**Rezoning Application:** PD 25-0469  
**Zoning Hearing Master Date:** July 21, 2025  
**BOCC CPA Public Hearing Date:** September 9, 2025

## 1.0 APPLICATION SUMMARY

This is a request to rezone a site to a Planned Development (PD) to facilitate residential single-family development. The majority of the site is currently zoned PD which was proposed to be open space for the purpose of meeting open space requirements and “sending” additional units to other areas of the PD. Subject site is designated the “Sending Zone” under the current PD zoning (23-0041, as most recently modified by PRS 24-1036). The remaining area of the proposed PD is currently zoned AR. The application is running concurrently with PD 25-0371 for a property located to the south, designated the “Receiving Zone” under the same existing PD zoning. Recently adopted CPAs (CPA 24-12 and 24-13) changed the site from the WVR-2 to RES-4 Future Land use Category and service area from Rural to Urban.

## AGENCY REVIEW COMMENT SHEET

## 2.4 Proposed Site Plan (partial provided below for size and orientation purposes. See Section 8.0 for full site plan)

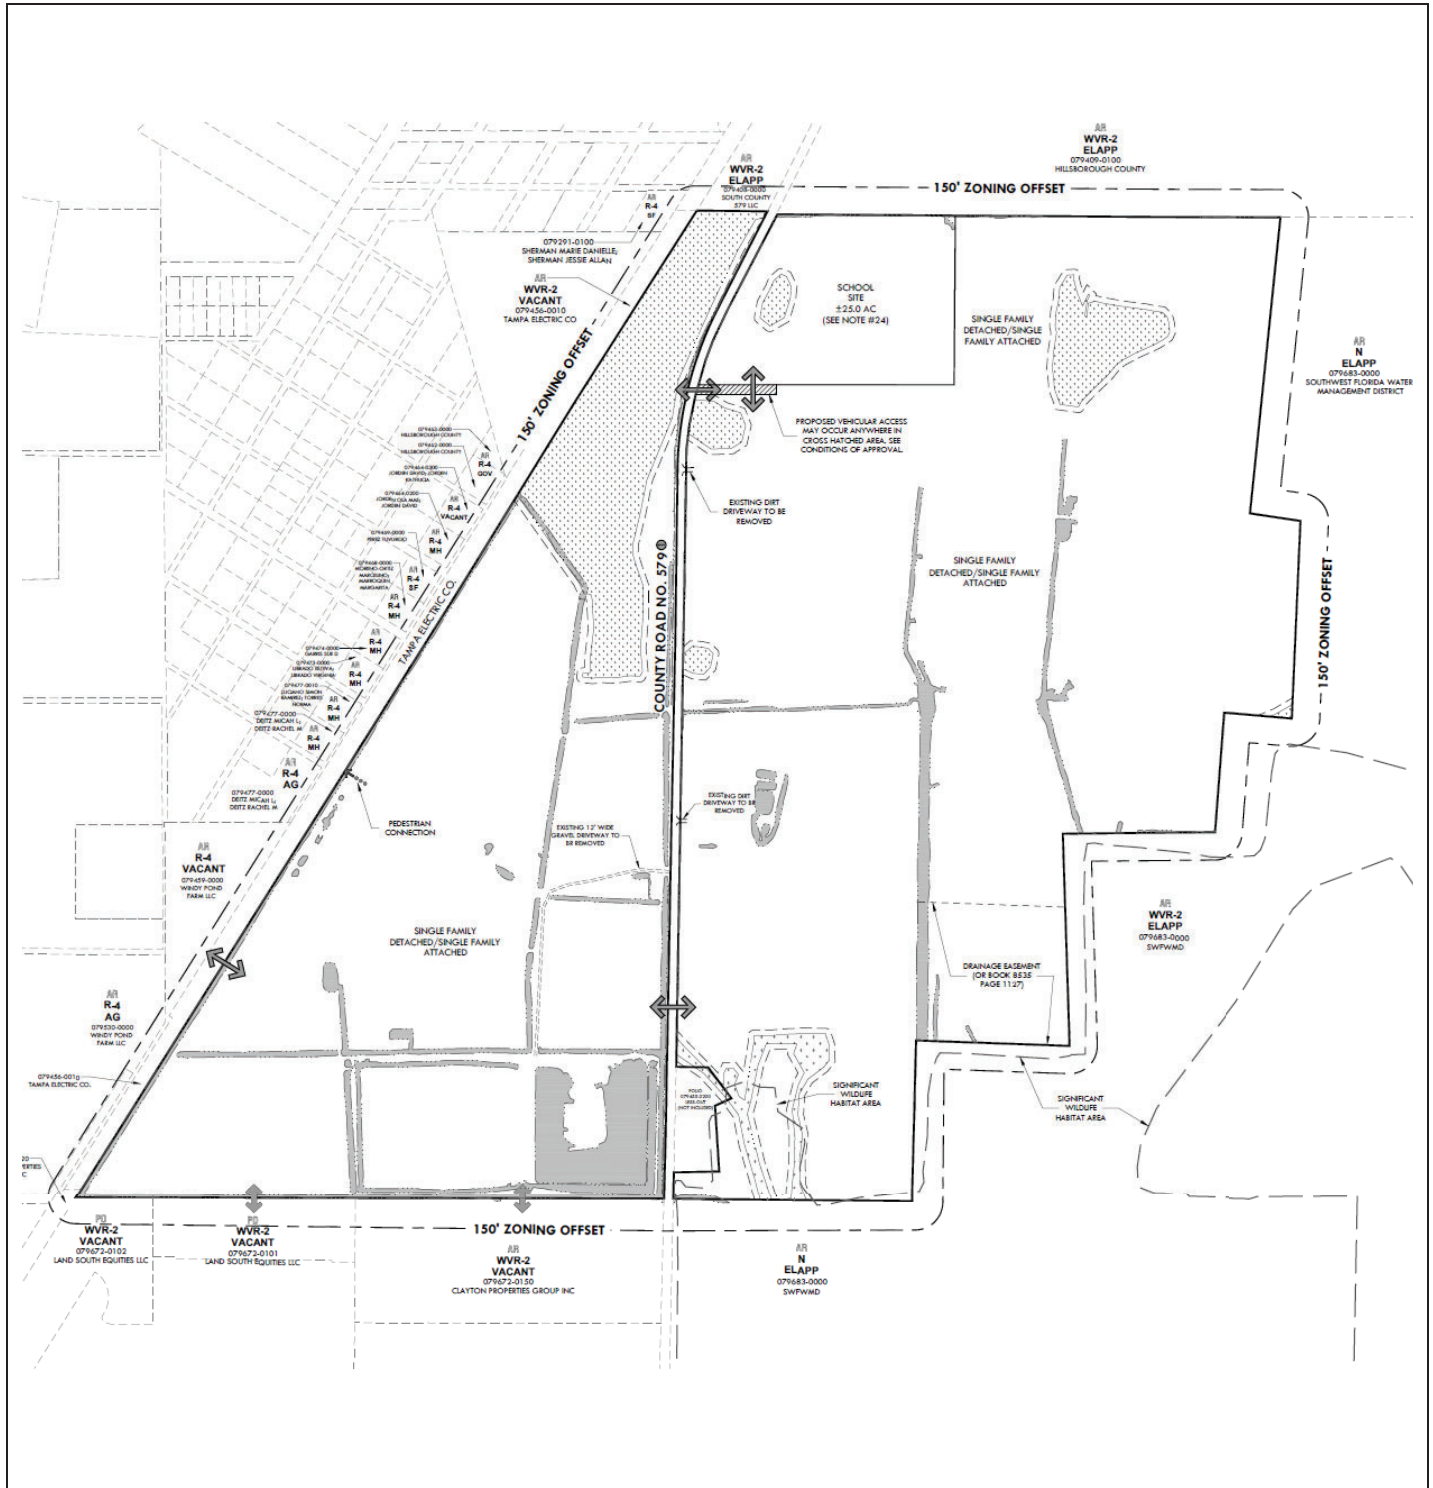
1. Prior to PD Site Plan Certification, the developer shall revise the PD site plan to:
  1. Correct the symbology for the southernmost stubout along the western PD boundary (staff notes it should use the access stubout symbology rather than the pedestrian/vehicular access symbology) and label as “Proposed Southernmost Roadway Stubout – See Conditions of Approval”.

2. Correct the symbology for the northernmost stubout along the western PD boundary (staff notes it should use the access stubout symbology rather than the undefined symbology used) and correct the label to instead read “Proposed Northernmost Roadway Stubout – See Conditions of Approval”.

4. Add labels at both project intersections on CR 579 and label as “Potential Signal/Roundabout/Other Improvement – See Condition of Approval”.
  5. Add labels/depict the approximate location of “Lesser Goldfinch Dr.” and “Redpoll Cliff Place” (reference Westlake Phase 2, Plat Book 148 Page 159 for additional information).

6. Label the unimproved right-of-way “F St.” (reference Plat of Halifax inset within the Revised Map of Town of Wimauma, Plat Book 1, Page 136).
  7. Revise Note 13 to instead state “Roadways within the Western Development Area shall be public. Roadways within the Eastern Development Area may be public or private. Roadways that are proposed to be maintained by Hillsborough County shall demonstrate consistency with Policy 4.1.4 of the Mobility Element of the Hillsborough County Comprehensive Plan.”

8. Revise Note 21 to replace the words “Access and” with the words “Except as otherwise specified in the zoning conditions.”
  9. Revise Note 25 to delete the duplicated “25.”

## SEGMENTS GRAPHIC

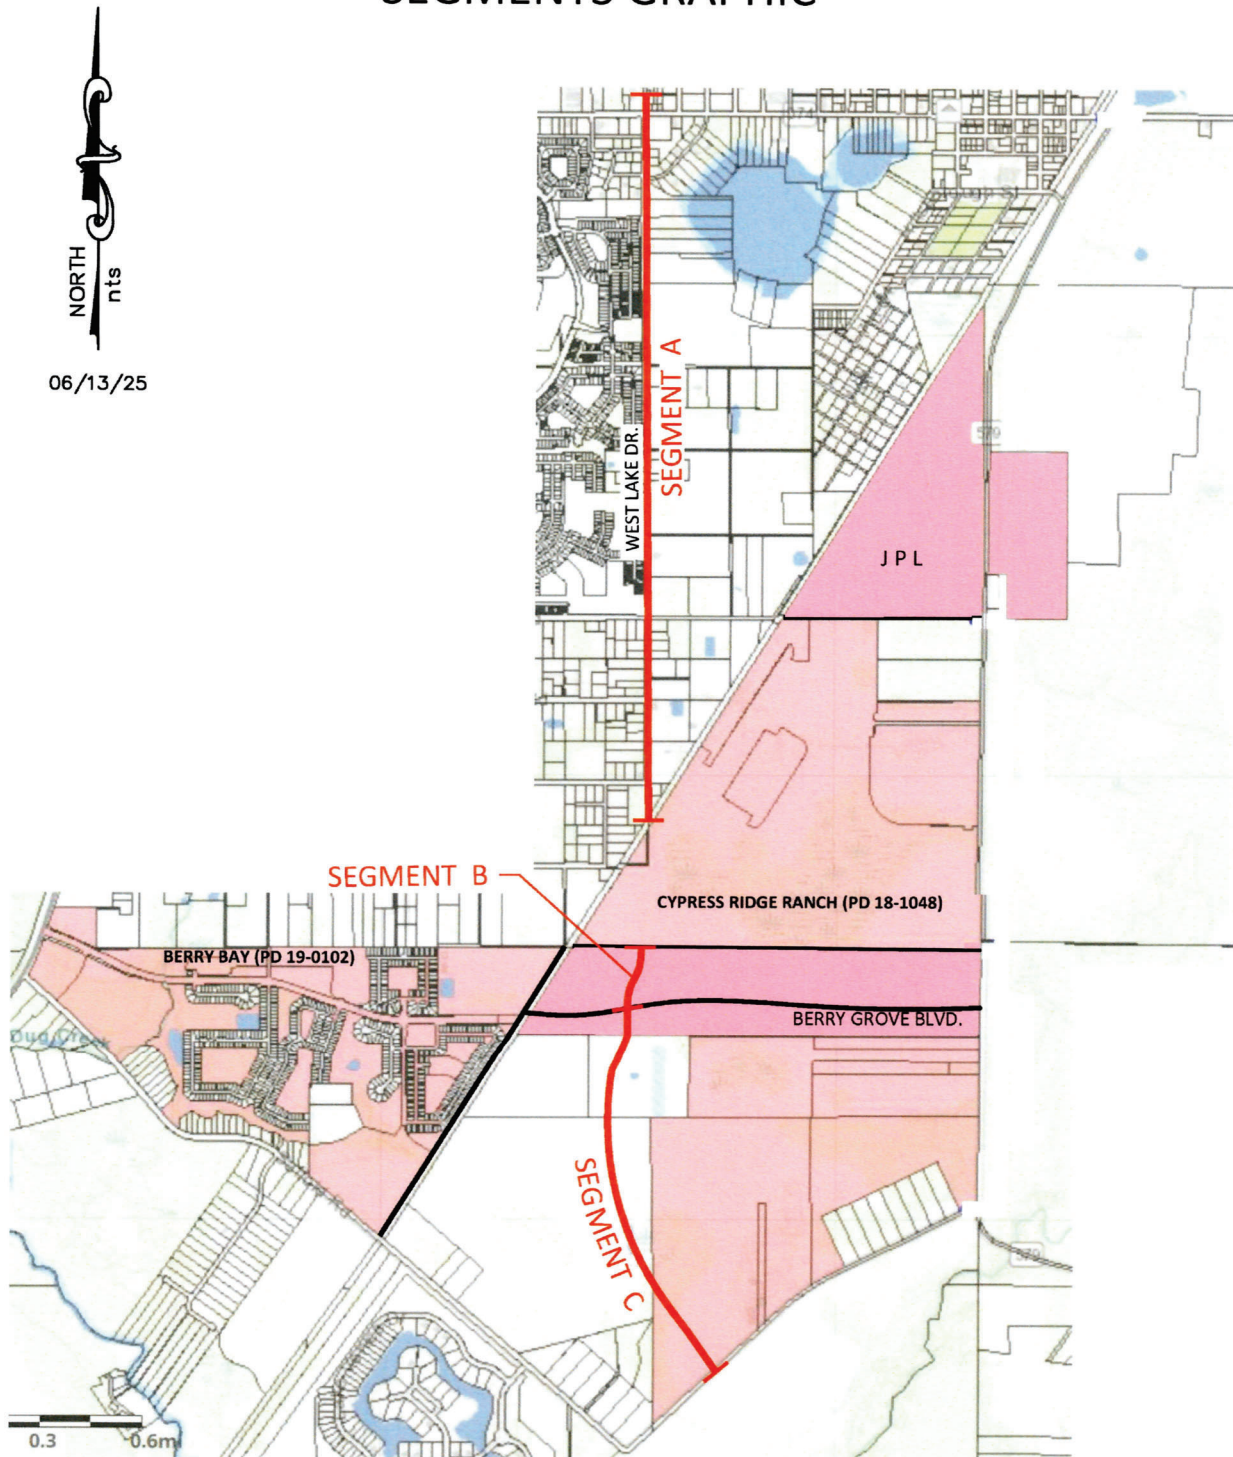
Staff notes that the graphic shown in the Design Exception request incorrectly depicts Segment A as inclusive of the area covered by Segment B. Staff has updated the graphic to reflect the correct summary and segmentation described hereinabove.

**SECTION A-1**

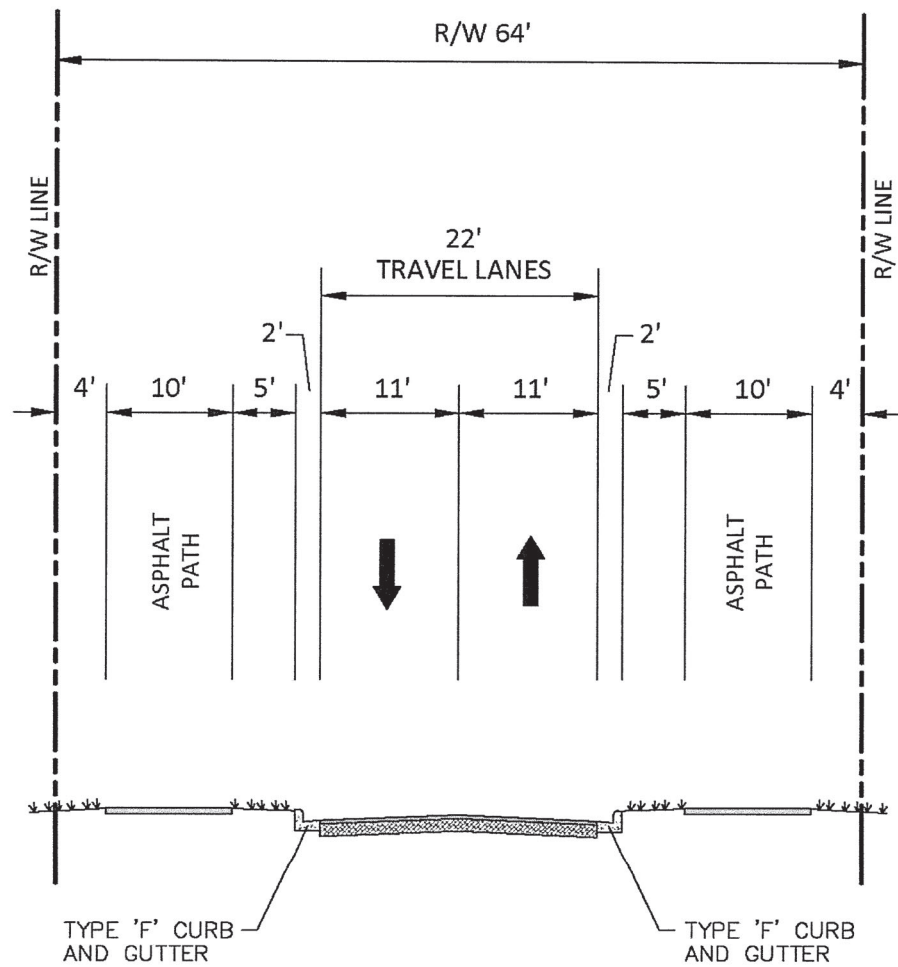
The developer proposes two (2) alternative sections. The first is where there is sufficient right of way to provide the proposed section which is shown in Typical Section A-1. Typical Section A-2 illustrates the proposed section where right of way is limited and/or there are design constraints. The primary difference in these sections is the distance from the back of the curb to the sidewalk. It should be noted that the distance between the back of the curb and sidewalk can vary depending on the right of way and roadway constraints. This section will be minimized to the greatest extent feasible. The sections include the following:

1. Bike Lanes – Due to the three (3) schools that are proposed along West Lake Drive, 10 foot sidewalks are proposed on each side of West Lake Drive in lieu of the bike lanes. From a safety standpoint, the 10 foot sidewalks provide a better option for students walking and riding bikes to school than students riding bikes within West Lake Drive or pedestrian and bikes on a 5 foot sidewalk. Due to right of way constraints along the roadway, it is not feasible to provide the bike lanes and the 10 foot sidewalks.
2. Sidewalk – 10 foot sidewalk on both sides of the roadway are proposed instead of the bike lanes. As stated above, given the roadway will serve the three (3) schools, the 10 foot sidewalks provide a better option for the school students.

**TYPICAL SECTION  
SEGMENT A  
C.R. 579**

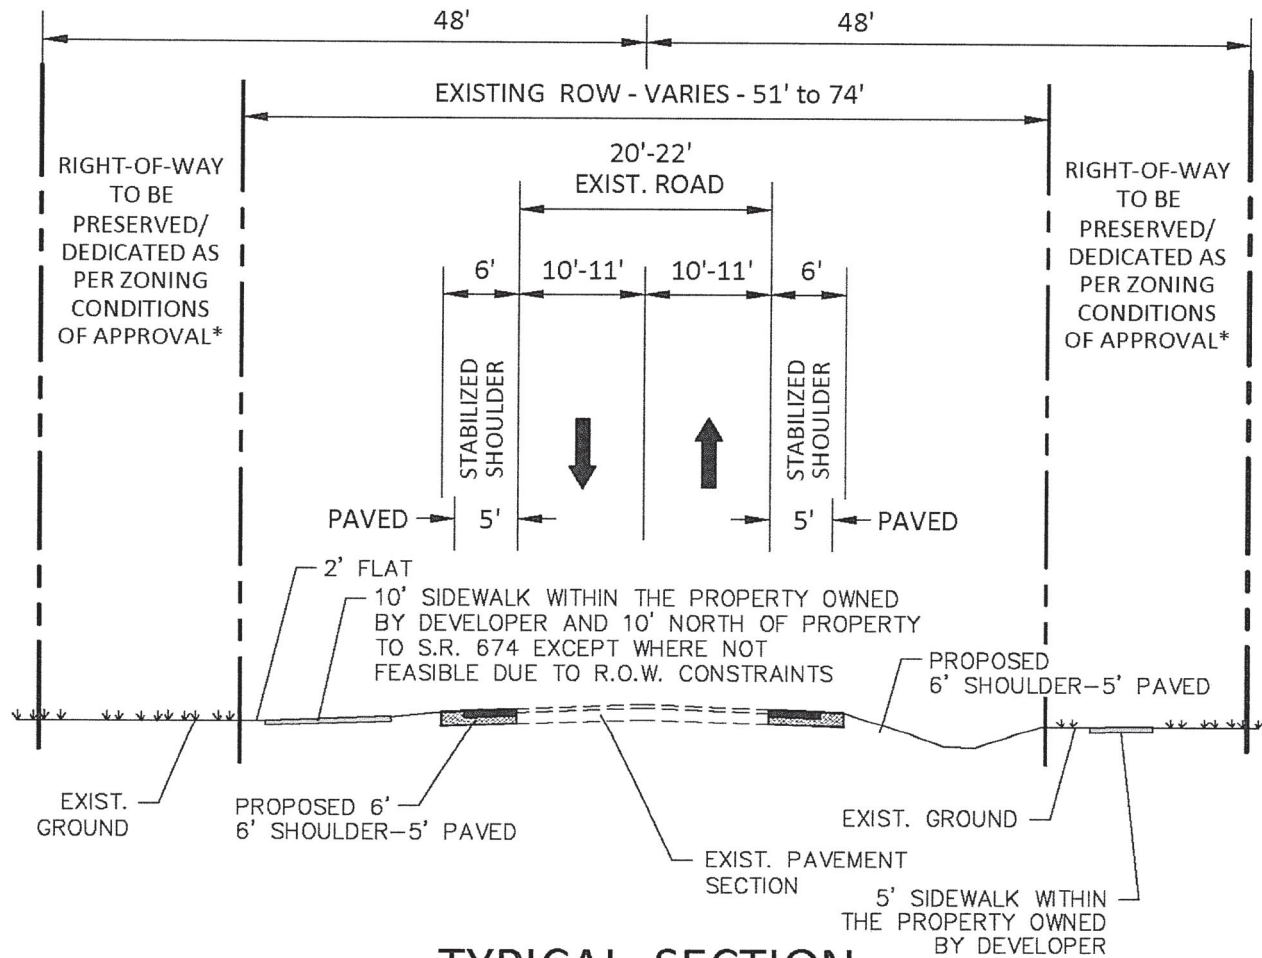
1. Right of Way – The right of way along this segment of CR 579 varies between approximately 74 feet to 90 feet. As shown in Figure 1, the developer does own property along the portion of the segment and has committed to providing 48 feet of right way on the west side to accommodate the proposed improvements.
2. Lane Width – TS-7 has 12 foot lanes. The existing lanes are 10 feet. This section proposes to maintain the existing lane width.
3. Shoulder – TS-7 has 8 foot shoulders with 5 feet paved. The proposed section has 6 foot stabilized shoulder with five feet paved.
4. Sidewalk – TS-7 has 5 foot sidewalk on both sides of the road. The proposed section provides a 10 foot sidewalk on the west side of CR 579.

**TYPICAL SECTION  
SEGMENT A  
SAFFOLD ROAD**

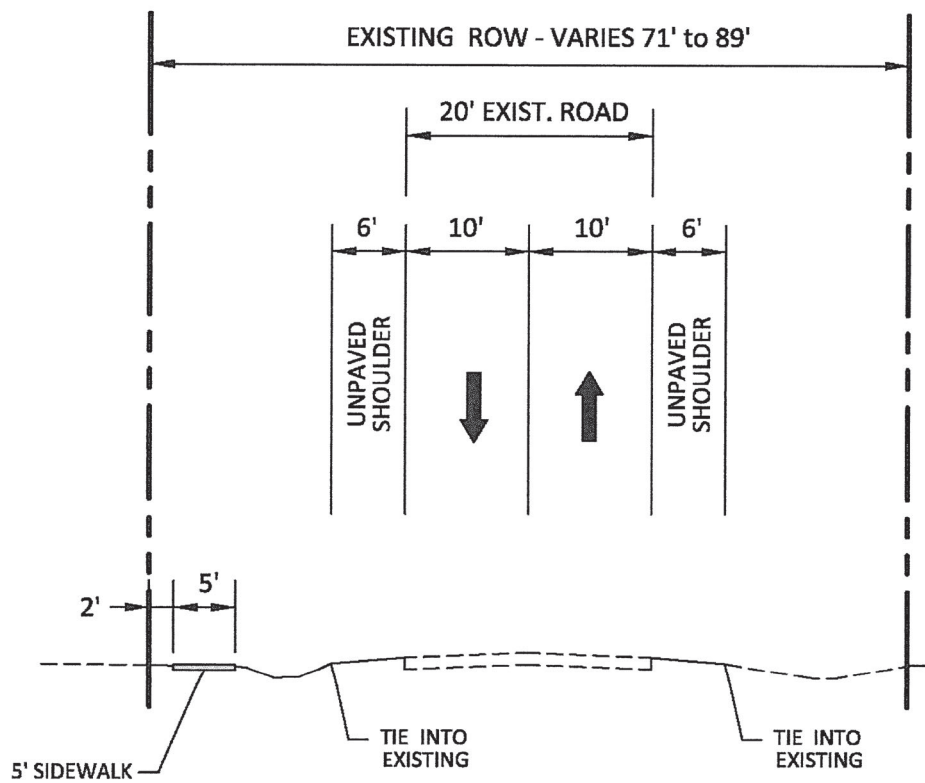
This section is along the portion of Saffold Road that the developer does not own any property. See Typical Section B for the section along the segment.

1. Right of Way – TS-7 has 96 feet of right of way. The right of way along the segment of Saffold Road varies between 71 feet to 89 feet.
2. Lane Width – TS-7 has 12 foot lanes. The proposed section is to maintain the existing lanes at 10 feet. Due to limited right of way, 12 foot lanes cannot be provided.
3. Shoulder – TS-7 has 8 foot shoulders with 5 feet paved. The proposed section has 6 foot stabilized shoulder.
4. Sidewalk – TS-7 has 5 foot sidewalk on both sides of the roadway. A 5 foot sidewalk is proposed along the north side of Saffold Road.
